Kenwood Village Project

Noise Study and Peer Review

Review of Sound Level Assessment

Kenwood Village Development
Goleta, CA

Figure 4. 24-hour Existing Sound Level Measurement

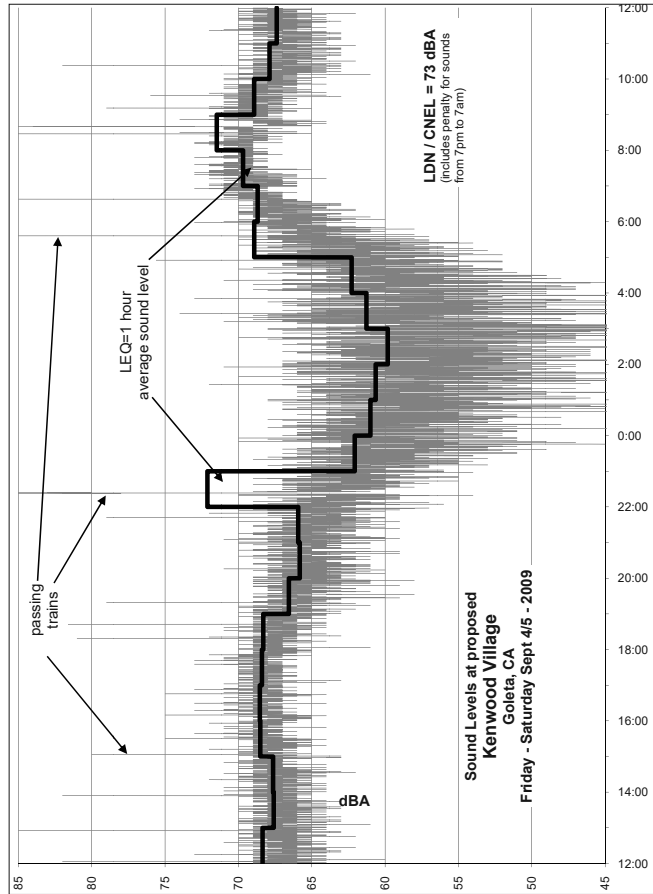
Page 5: It is stated that measurements were taken from Friday Sept 4 through Saturday Sept 5, 2009. From Figure 3 on Page 7, it can be inferred that this means from noon on Friday to noon on Saturday, so that weekday morning traffic noise is not included. The Reviewer's assessment is that for this project, the peak a.m. traffic noise on Friday would not be higher than the peak a.m. traffic noise shown for Saturday. Further, evening and post 10 p.m. noise tends to be higher on Fridays than other weeknights, so it is likely the measurements slightly overstate the average condition.

Page 7: Based on the caption of Figure 3, the graph truncates at least one and possibly several transient noise events. The referenced web site "Details" state that the peak train sound level was measured to be 94 dBA (sic). The Reviewer's assessment of the data shown in the "Details" is that 94 dB is the Leq10sec at 22:22:15, and that the peak sound level could be several dB higher. <http://45db.blogspot.com/2010/02/kenwood-village-goleta-ca.html>

Figure 7. Existing Sound Level Contours, no development

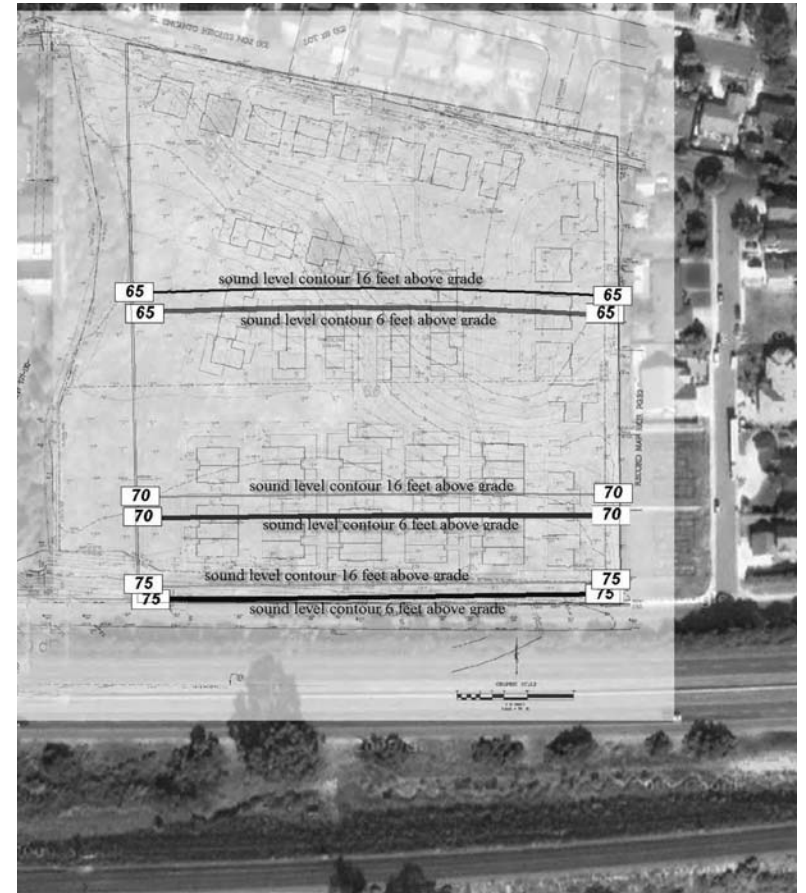
Page 10: Although the noise contours appear reasonable and to have been correctly calibrated to match the measurement results near the south end of the site, the color legend on the figure ought to be fixed so that it matches the color scale of the contours, or else deleted.

Page 10: The bare site contours are computed at 6 feet above site grade. It is not indicated why this elevation was chosen. The *de facto* outdoor noise measurement height is 5 ft, although ASTM E1014 (section 8.1.7) states between 4 and 5 ft is acceptable. The Assessment Appendix states that the ASTM standard is 5 ft 6 in, but this appears to be incorrect. The Assessment implies that the measurements were taken at 5 ft 6 in, which would have little effect compared to 5 ft for bare site conditions. Similarly, the contour calculation at 6 ft would not be expected to differ significantly from 5 ft.

Figure 8. Future Sound Level Contours at 6 feet

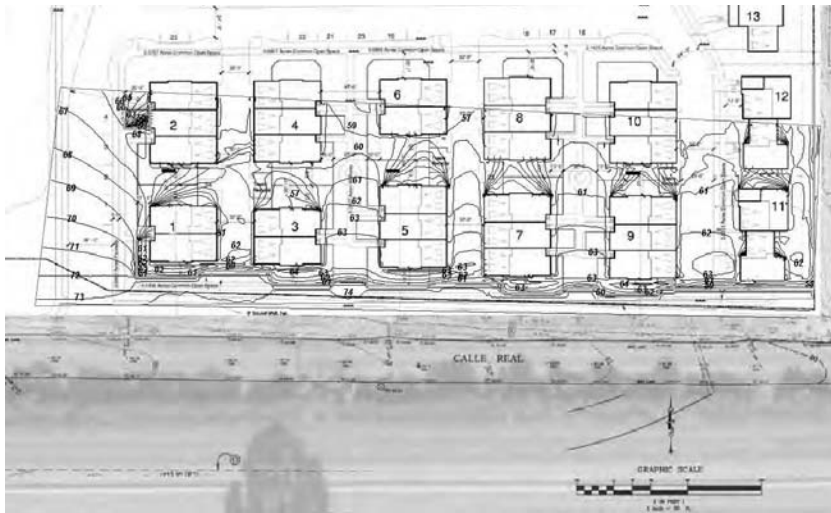
Page 12: Figure 8 is very hard to comprehend, apparently showing 62-65 dB range noise contours inside Building 2 and indicating no reflected sound from the west wall of the building or the north patio wall of the middle unit. This issue is probably related to the disregard of reflections discussed above.

Figure 1. Simplified Model with No Sound Reflections

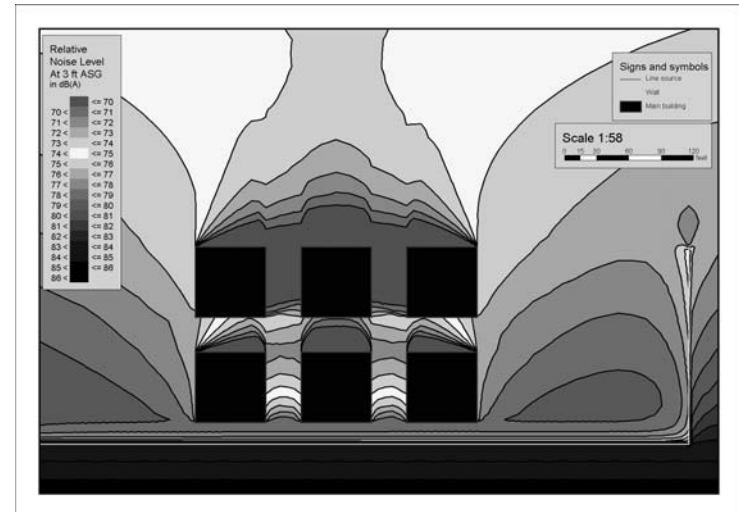
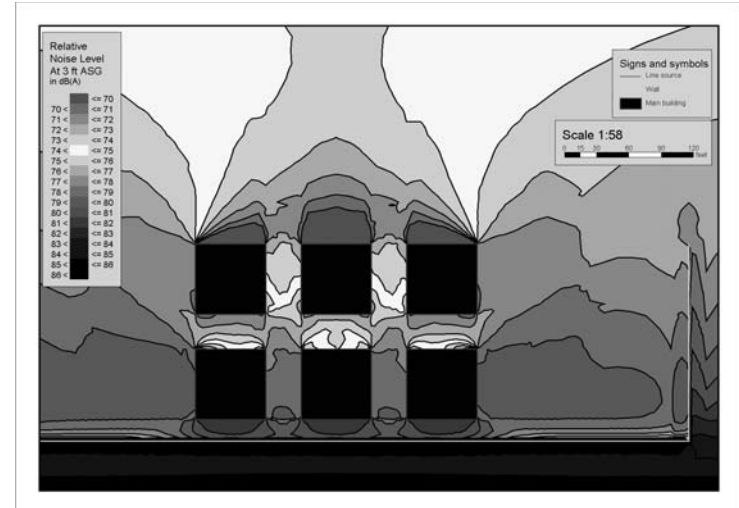
Page 11: The Reviewer is not directly familiar with CADNA/A, but has extensive experience with SoundPlan, which runs the same ISO 9613-2 calculation model. It appears doubtful that the CADNA/A model used in the Assessment has been set up with appropriate sound reflection characteristics for the modeled buildings. As an example, the two contour plots shown below were computed at 3 ft ASG for a highly simplified model of the southern area of the project using an arbitrary line source centered 5 ft above the westbound side of Hwy 101 and generating 10 mW acoustic power per meter (apparently about 10 dB greater than the sound power modeled in the Assessment). The barrier is 8 ft tall and the buildings are modeled as 18 ft tall. Figure 1 ignores reflections from the buildings and barrier while Figure 2 includes them. Despite the oversimplification, the greater resemblance of the “no reflections” graph to Assessment Figure 7 is evident.

The Reviewer has subsequently learned that, whereas SoundPlan’s default condition is to include reflections up to third order, CADNA/A requires the user to activate reflections in the model setup. Sound modeling should be conducted to account for reflected noise. Not accounting for reflected noise would definitely result in an optimistic prediction of outdoor sound levels.
